Well Name: BLUE CHIP 14 FEDERAL COM	Well Location: T21S / R32E / SEC 11 / SESE / 32.4887737 / -103.6376871	County or Parish/State: LEA / NM
Well Number: 511H	Type of Well: OIL WELL	Allottee or Tribe Name:
Lease Number: NMNM14155	Unit or CA Name:	Unit or CA Number:
US Well Number: 3002554894	Operator: MATADOR PRODUCTION COMPANY

Notice of Intent

Sundry ID: 2899403

Type of Submission: Notice of Intent	Type of Action: APD Change
Date Sundry Submitted: 03/09/2026	Time Sundry Submitted: 02:31
Date proposed operation will begin: 03/09/2026

[Figure D] 4 String – Uncemented annulus between 1st and 2nd Intermediate casing strings

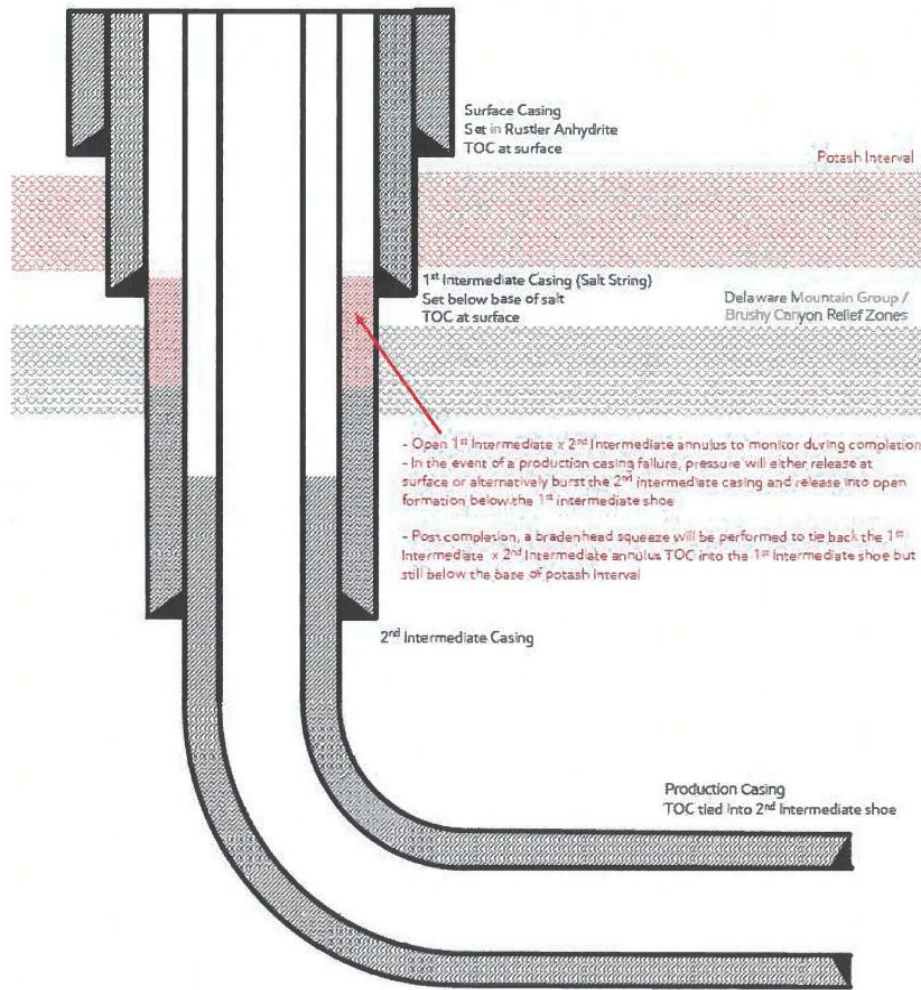
Option B: 4-string design per figure D in R-111-Q. Will drop intermediate-2 string, if hole conditions allow.

Option D: 4-string design per figure D in R-111-Q. will drop intermediate-2 string, if hole conditions allow.

Plan B (4-String Design: Open 1st Int x 2nd Annulus (ICP 2 below Relief Zone))

3. The **7-5/8 inch 2nd** intermediate casing shall be set in a competent bed at approximately **12,234 ft.** (12,137 ft. TVD). The minimum required fill of cement behind the **7-5/8 inch** intermediate casing is:

- ❖ A monitored open annulus will be incorporated during completion by leaving the 2nd Intermediate Casing x 1st Intermediate Casing annulus un-cemented and monitored. Operator must follow **all** monitoring requirements listed within R-111-Q. Tieback shall be met within **180 days.**

[Figure E] 4 String – Uncemented Annulus between 2nd Intermediate and Production Casing Strings

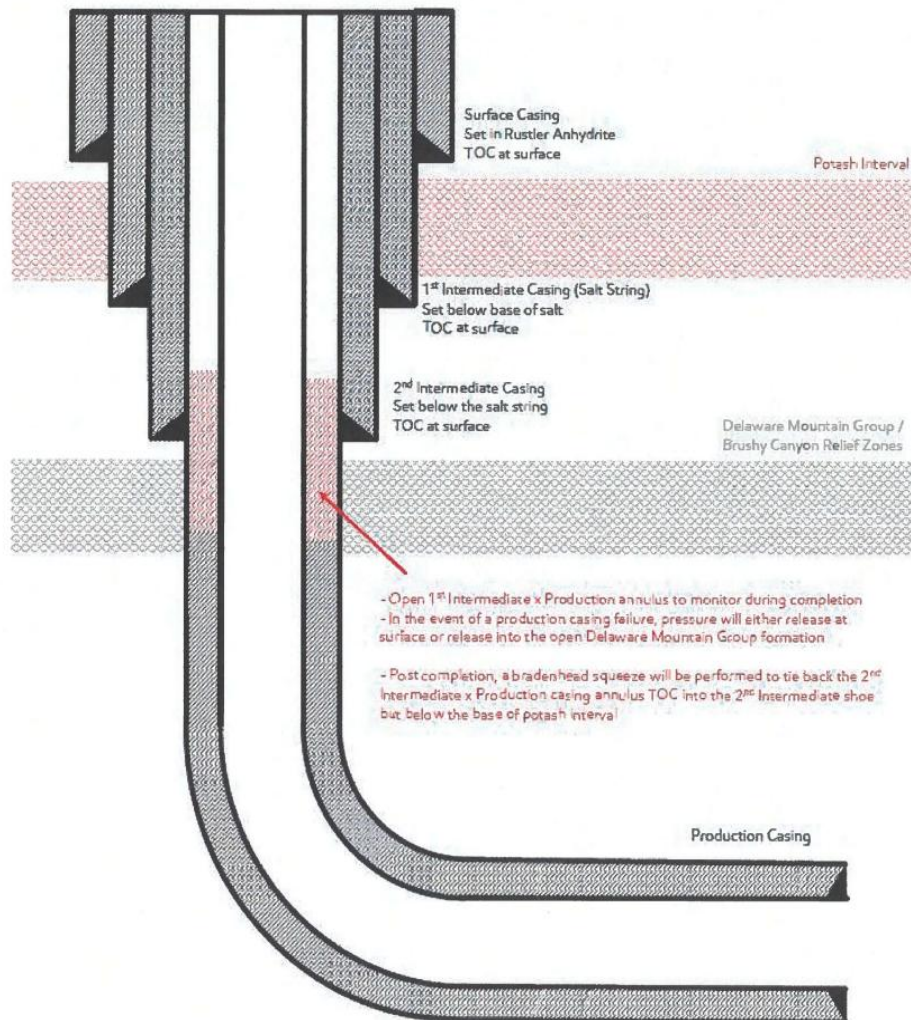
Option C: 4-string design per figure E in R-111-Q . Will drop intermediate 3 string, if hole conditions allow.

Plan C (4-String Design: Open 2nd Int x Production Casing (ICP 2 above Relief Zone))

- ❖ Operator has proposed an open annulus completion in R-111-Q. Operator shall provide a method of verification pre-completion top of cement. **Submit results to the BLM.**

- ❖ **Operator must verify top of cement per R-111-Q requirements.** Submit results to the BLM. If cement does not circulate, contact the appropriate BLM office. If cement does not tie-back at least 500 ft. into the previous casing shoe, the appropriate BLM office shall be notified.
